**PROPOSED 20-MW SOLAR PHOTOVOLTAIC PROJECT
CANDLEWOOD MOUNTAIN ROAD
NEW MILFORD, CONNECTICUT
CANDLEWOOD SOLAR, LLC – APPLICANT**

**PREFILED WRITTEN TESTIMONY OF
VINCENT C. MCDERMOTT, FASLA, AICP
AND
MATTHEW J. SANFORD, PWS
MILONE & MACBROOM, INC.**

MAY 6, 2019

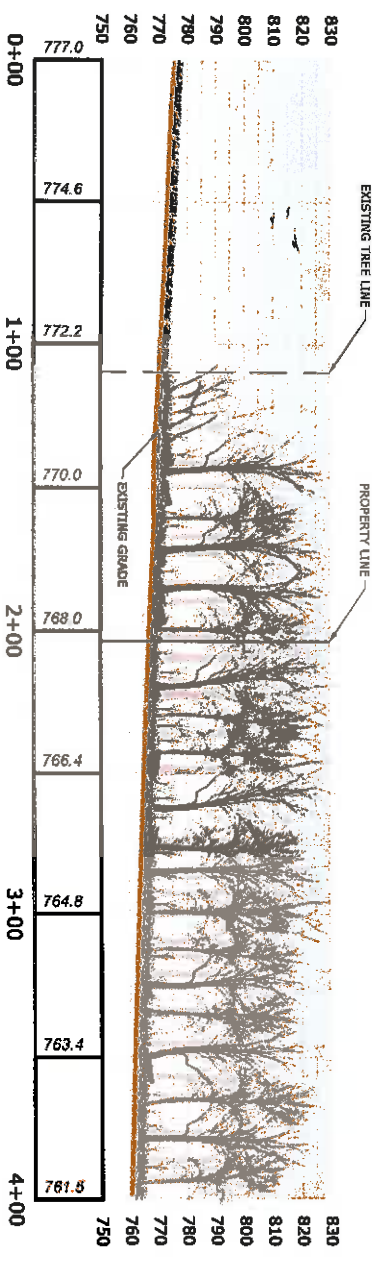
The solar arrays will have minimal if any direct visibility from the Candlelight Farms Inn. However, the removal of vegetation for the improvements to the access road and clearing for the arrays will open the forest canopy. More importantly, the mobilization area for construction in the field to the north of the inn will be fully visible. (See Attachment B, Photos F1 and F2.)

CROSS SECTION A
 CANDLEWOOD SOLAR PROJECT
 EXISTING & PROPOSED CROSS SECTIONS
 CANDLEWOOD MOUNTAIN
 NEW MILFORD, CONNECTICUT

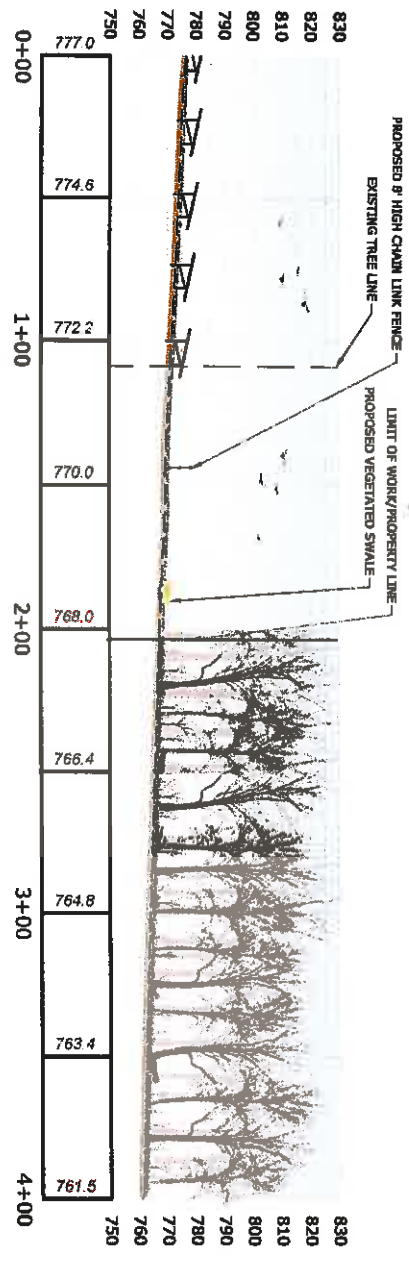
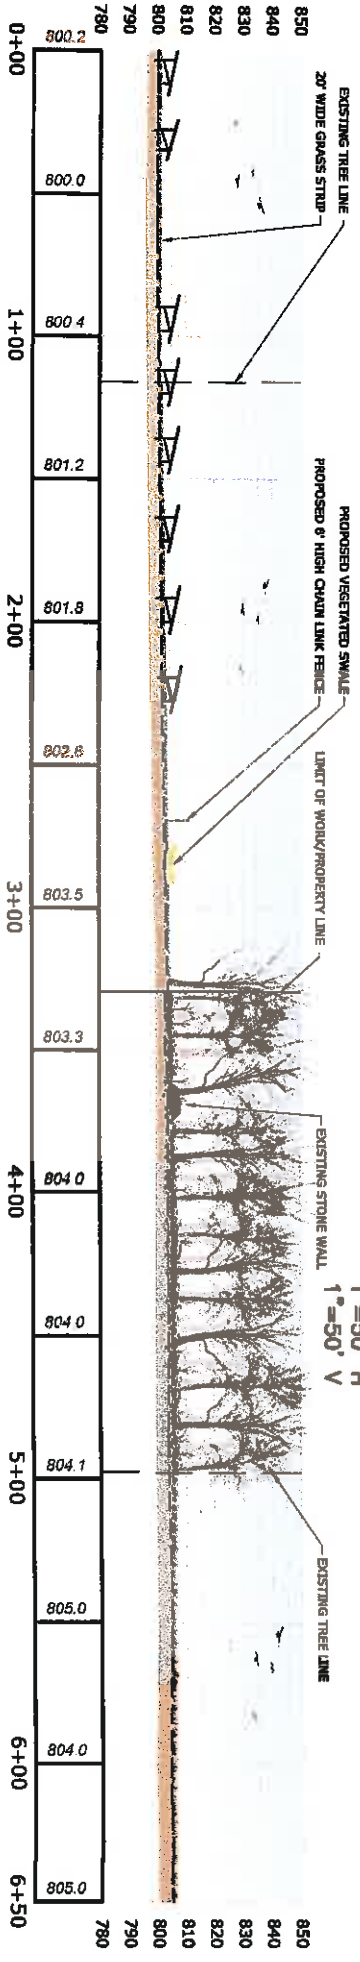
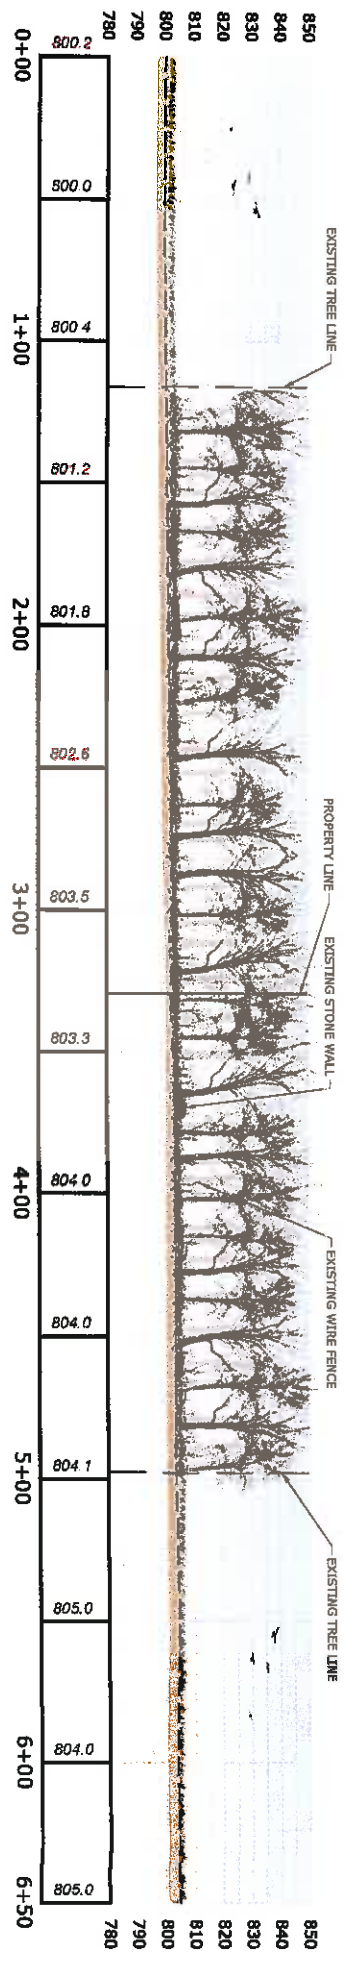
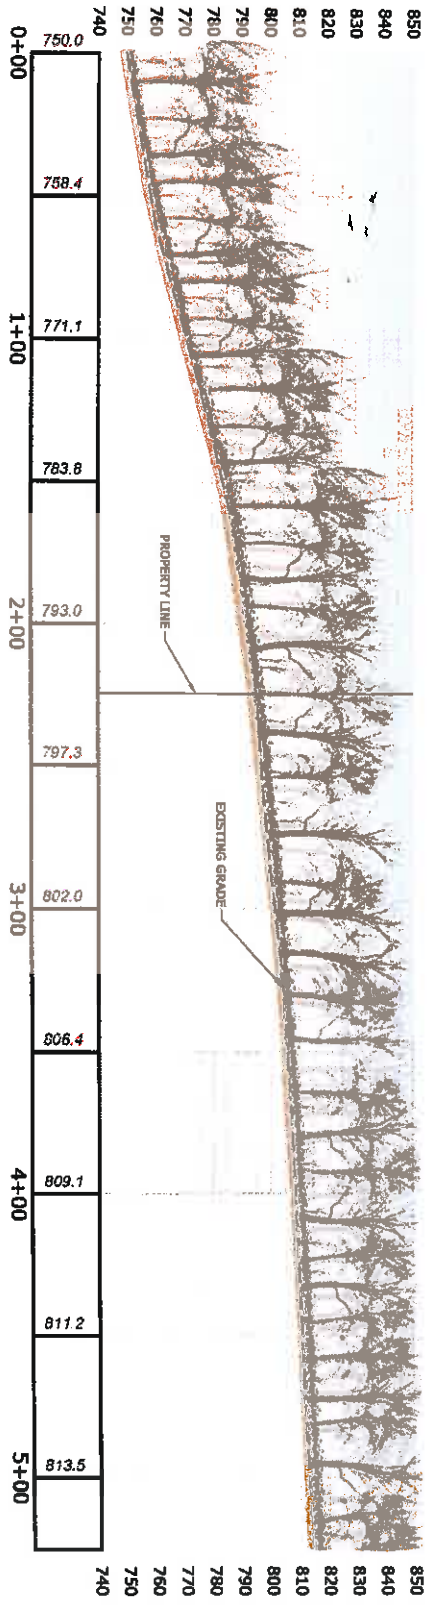
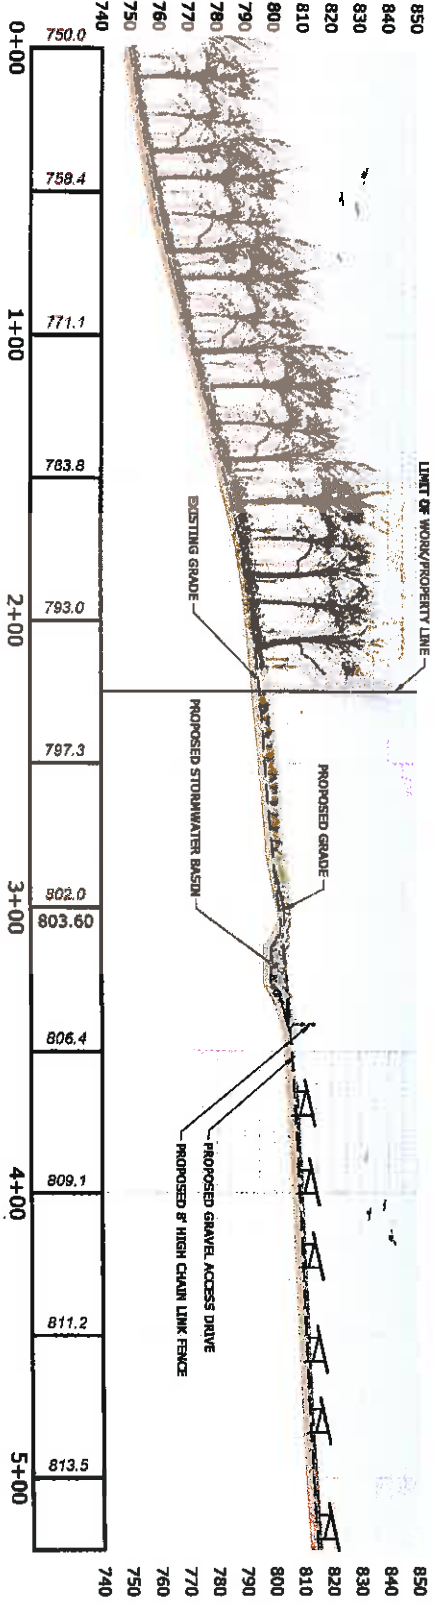
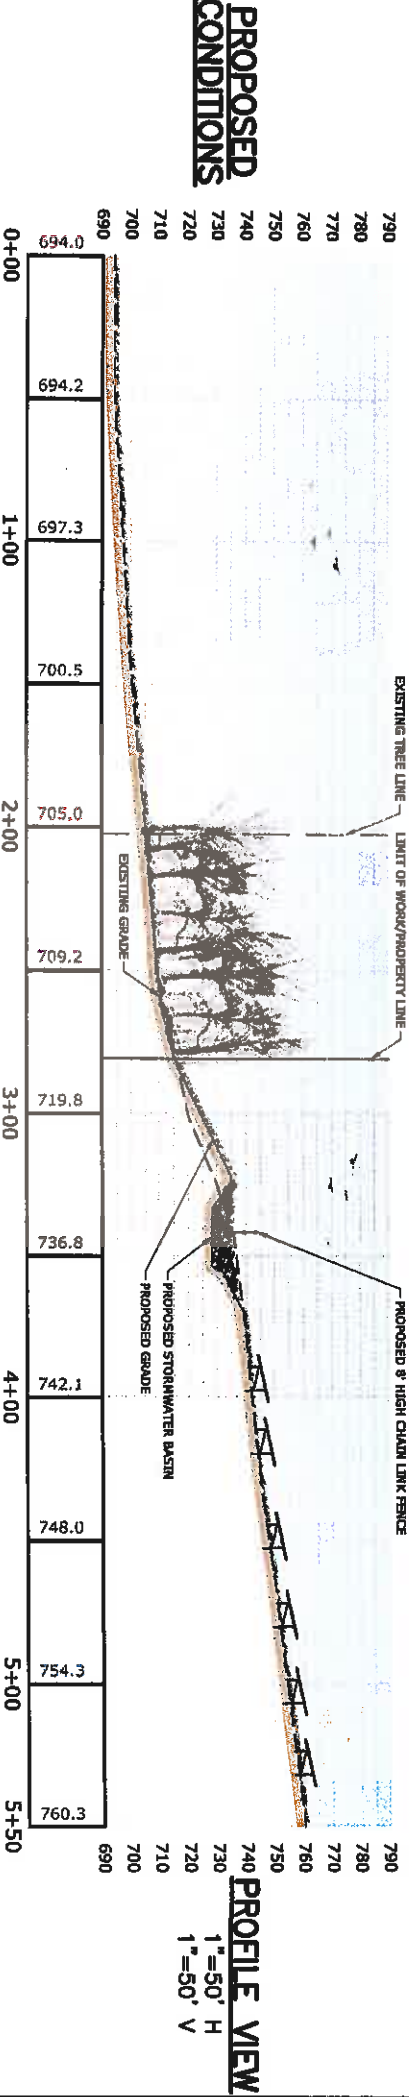
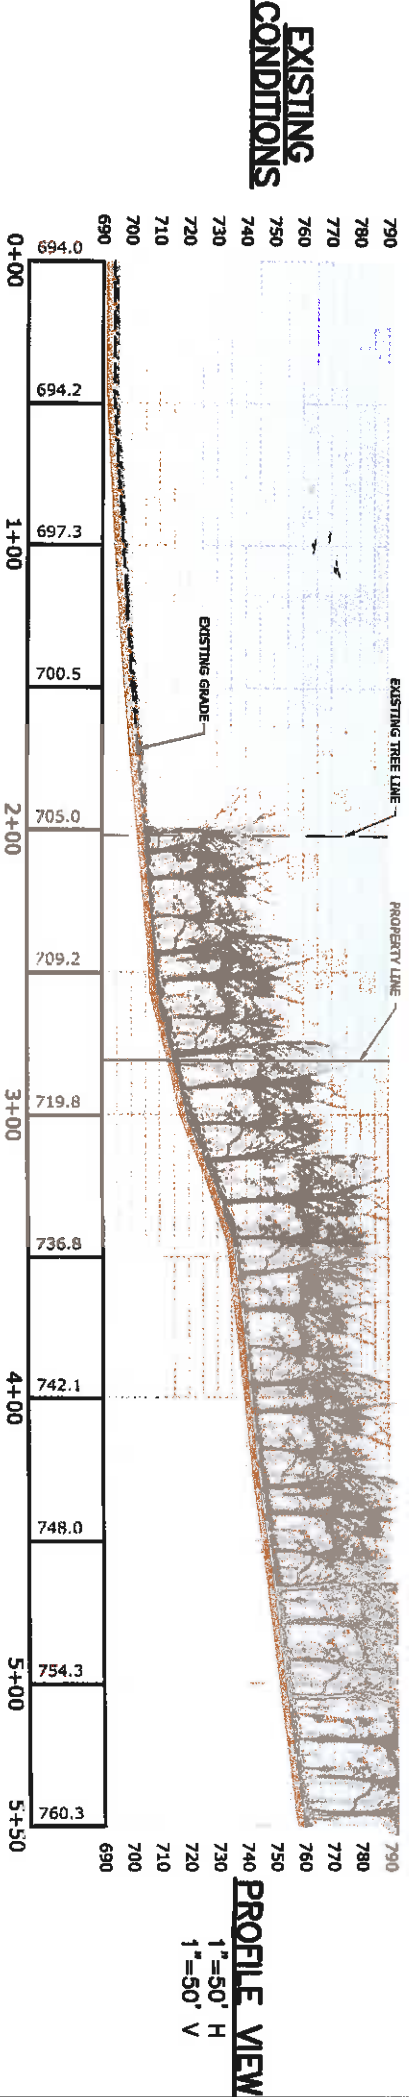
- Q. How would you summarize the visual impacts of the development on the surrounding residential properties to the south and west?**
- A. Contrary to the assertions made by CS (Finding of Fact #218), the proposed solar arrays and related site improvements will be visible to the residential properties located on Candlewood Mountain Road to the west of the site. The arrays will be approximately 75 feet from the residential property lines, and there will be significant removal of trees and construction of drainage improvements along the property lines on the slopes facing the residential properties thereby opening the visibility to the site. (See Attachment C.)
